ADDENDUM
to
ENVIRONMENTAL IMPACT ASSESSMENT

BAHIA PRINCIPE HOTEL
RESORT DEVELOPMENT

PEAR TREE BOTTOM
ST. ANN, JAMAICA

MAY 2005

Figure showing topographic contours – substitute for Fig. 3.1.2 in EIA report.

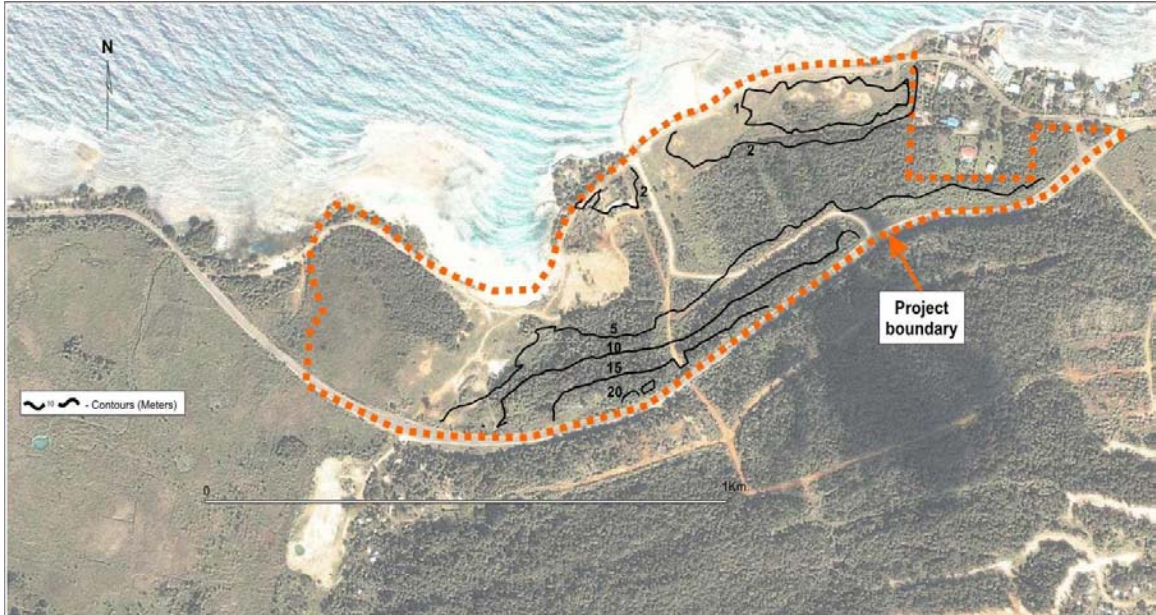
- The figures presented in the EIA, especially those with the aerial photographs as the backdrop are of poor quality and need to be addressed. This is especially the case where the colours (light yellow, pale yellow) used to highlight the various components of the hotel development are camouflaged by the vegetation (green colour).

As worded, the comment incorrectly suggests that all the figures presented were of poor quality. Figures 3.1.2 and 4.1 have been redone and are provided in the Appendix below

Figure showing master plan of resort – part substitute for Fig. 4.1 in EIA report.

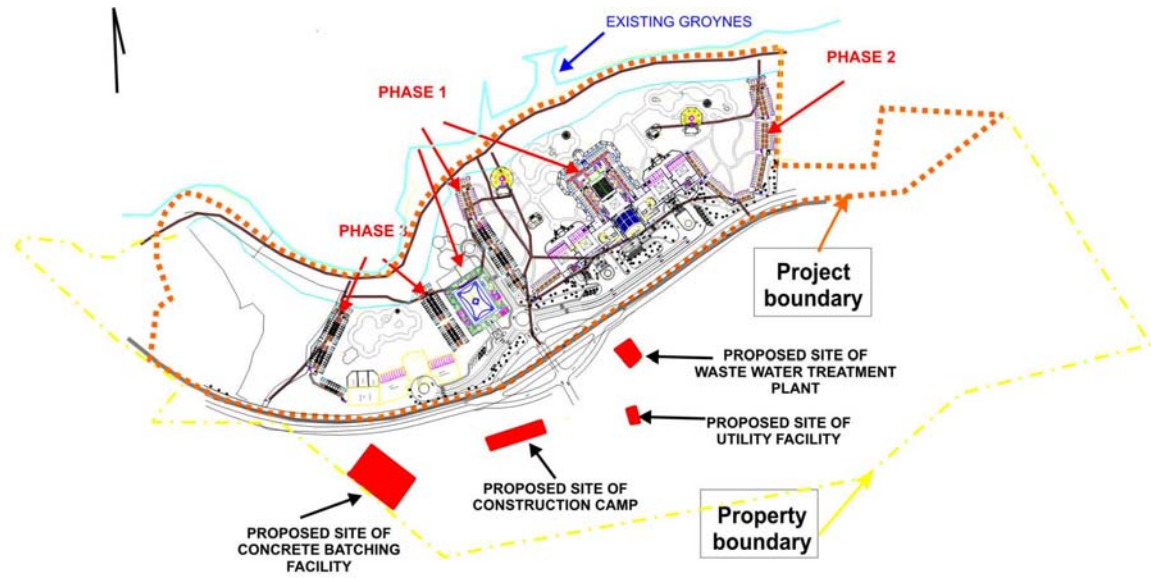
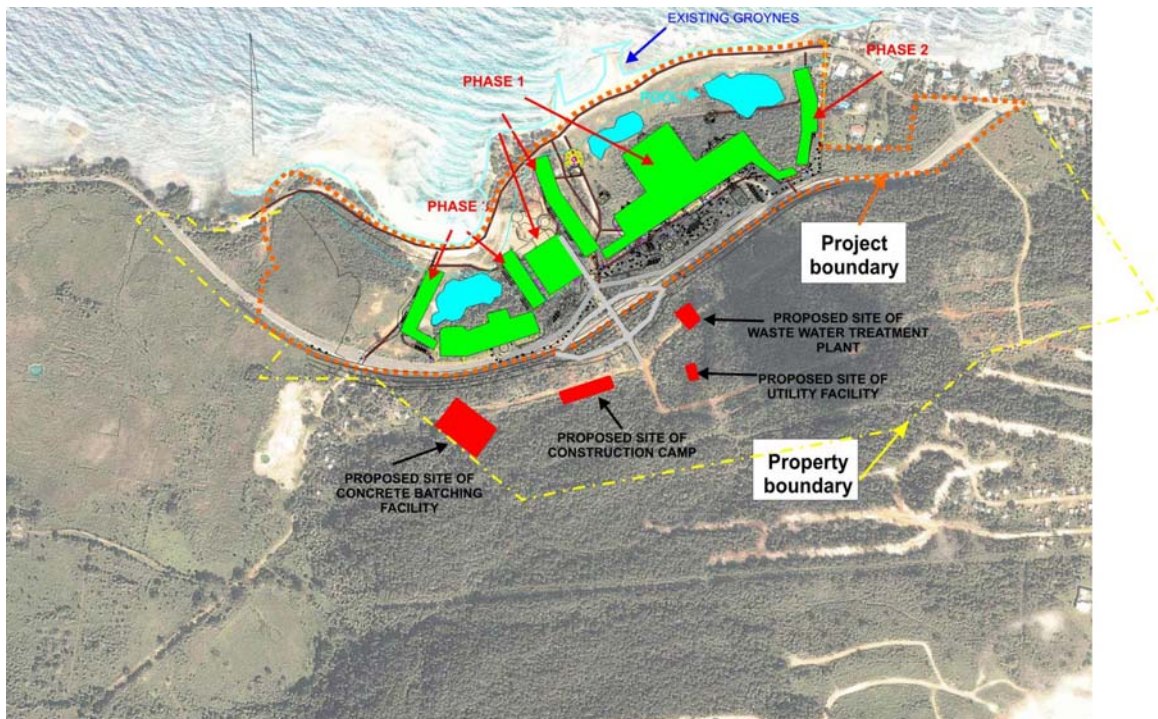
- **Page 79, Section 4.2.1 – Site preparation activities.** The location of the plant nursery is not evident on Figure 4.1 (Page 78).

The exact location has not been determined. Initially it is intended to use the facilities of a landscape operation near to Green Grotto
